**FINAL ENVIRONMENTAL ASSESSMENT FOR A
SHORELINE SETBACK VARIANCE APPLICATION**

CONSTRUCTION OF A SEAWALL

45-002 Lilipuna Road, Kaneohe, Hawaii

SUBJECT: Review: Draft Environmental Assessment
Request: Shoreline Setback Variance
File No.: 2003-ED-34 - TMK: (1) 4-5-001: 039
Authority: C&COH Department of Planning and Permitting
Applicant: Dr. Sevath S. Tanaka
Project: Construct CRM retaining walls within setback
Address: 45-002 Lilipuna Road, Kaneohe, Oahu, Hawaii

Figure 5
SEA WALL DETAIL

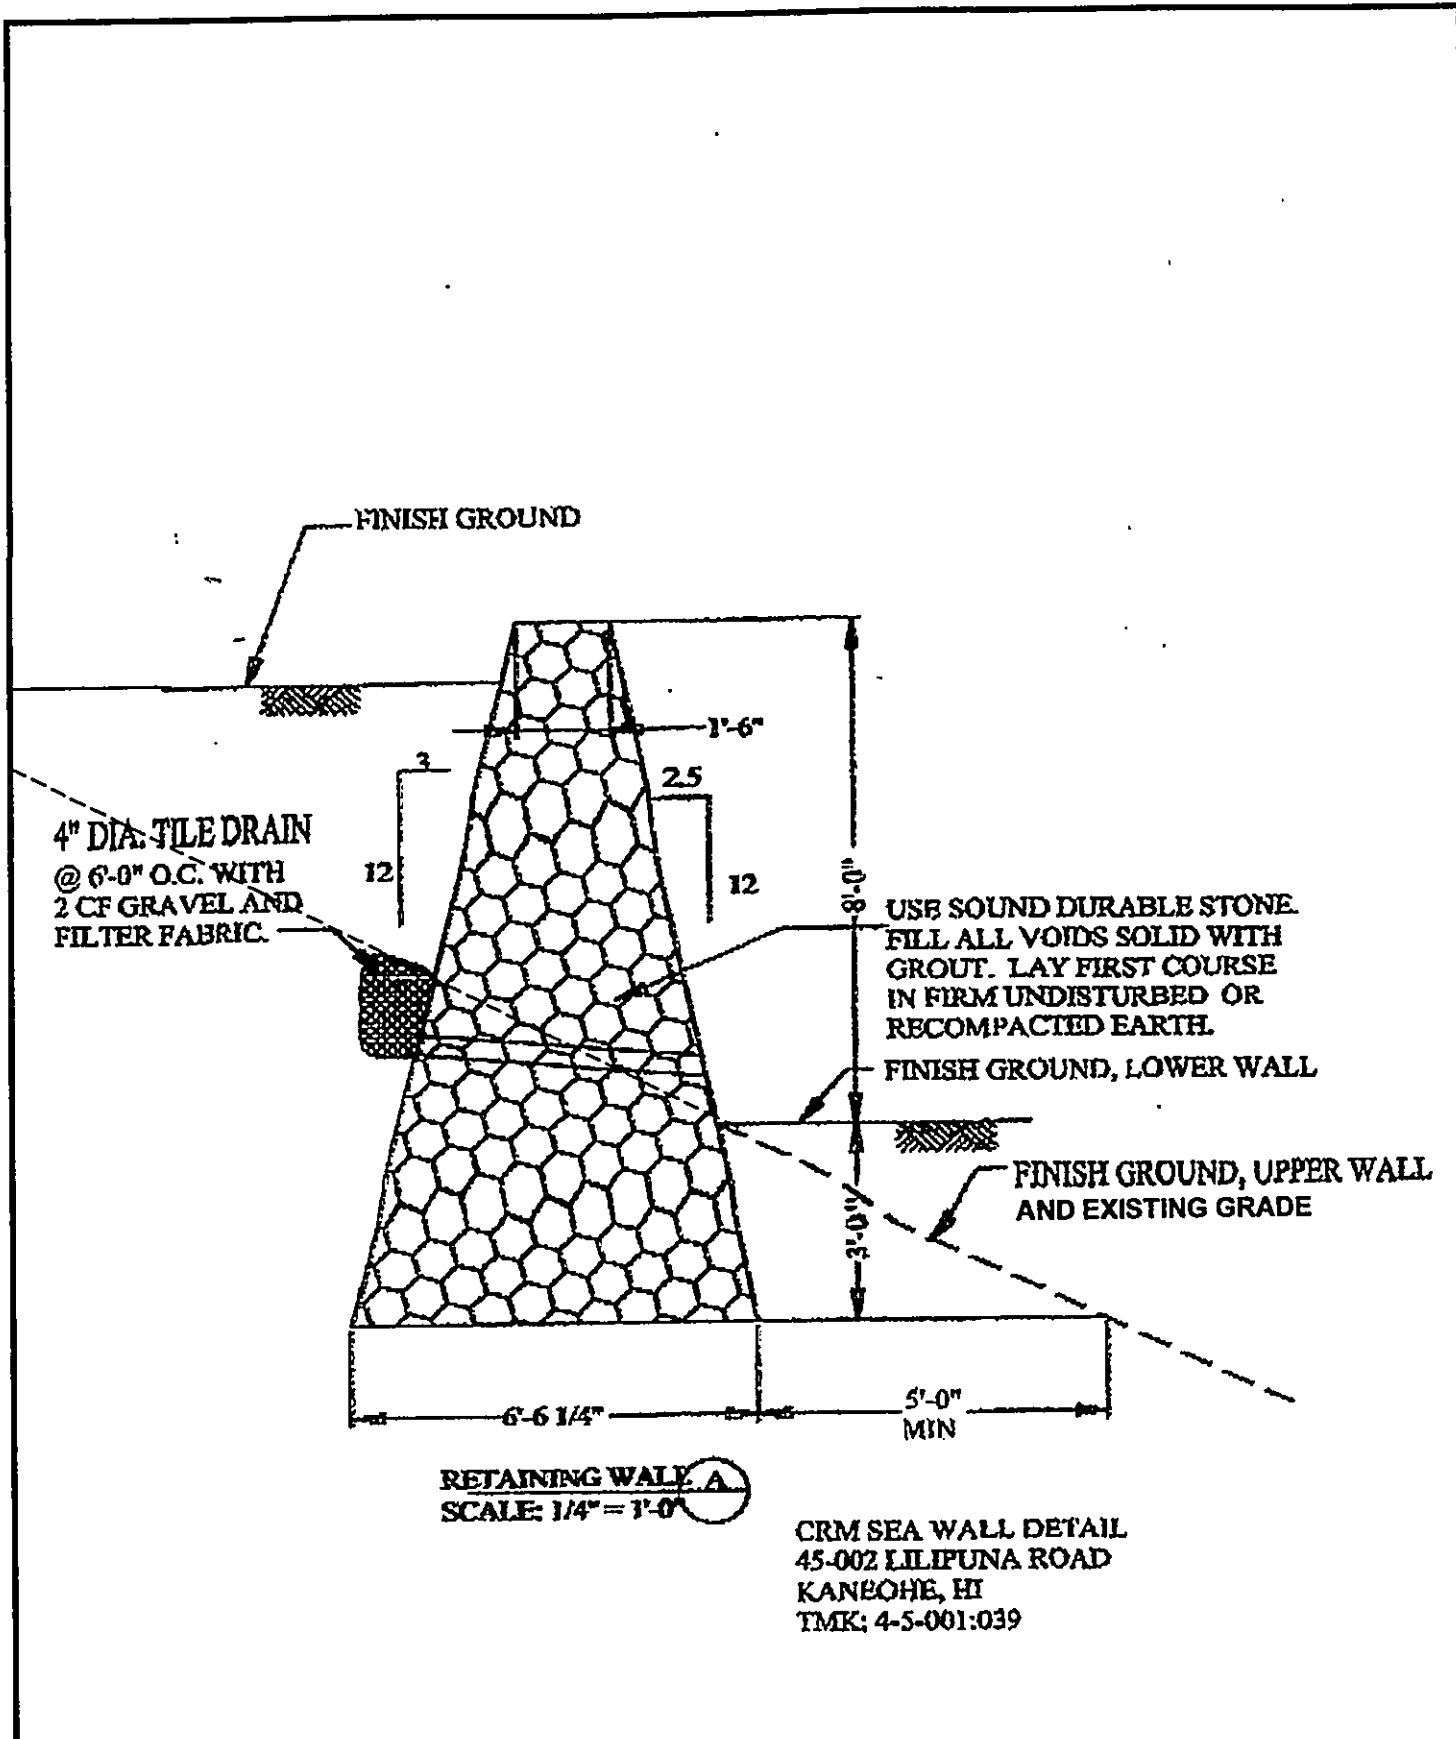
1. Include the amount of fill material anticipated. A grading permit may be required.
2. Section 2.2: a) Considering that the wall will be located along the shore, is the 1'8" wall embedment depth adequate to prevent undermining? b) Detail B/A-1 shows that the wall is located outside the property. c) Show the correct location of the existing grade.
3. Section 4.1: Describe mitigative measures (BMPs) that may be implemented during construction.
4. Does the site have lateral access along the shoreline?
5. Scaled plans of the retaining wall, stamped by a professional engineer should be included in the Final Environmental Assessment (FEA).

2. **Proposed Wall Section 2.2.** A revised Figure 5 depicting the proposed wall has been included in the Final Environmental Assessment. The revised Figure 5 and additional written information provided in "Section 2.2 Project Description" address the issues raised in your comment letter: wall embedment depth will be three feet deep (3 feet) throughout the entire wall length; the location of the property line was erroneously depicted in the Draft EA's Figure 5 as the entire wall is located on the owner's property; and location of existing grade is shown in the revised Figure 5.
